PIL #23-004

RPL & MXL Drivelines Centre Bearing (with new double lip seal)

Product Information Letter #23-004

Figure 1. Sectioned view of the centre bearing (seal lip area enlarged)

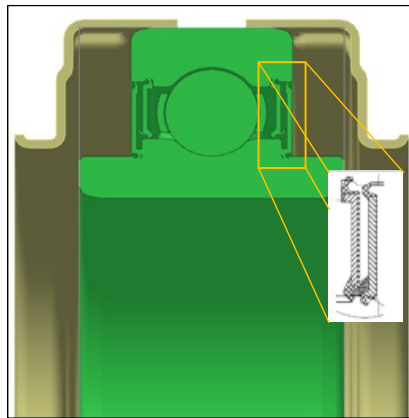
The product improvement is the inclusion of a new double lip seal that enhances the protection of the permanent lubricated driveshaft bearing (see figure 1).

- MXL18 Drivelines: CCB213 (OLD) → CCB216 (NEW)
- RPL25 Drivelines: HCB214 (OLD) → HCB217 (NEW)
- RPL35 Drivelines: MCB203 (OLD) → MCB206 (NEW)
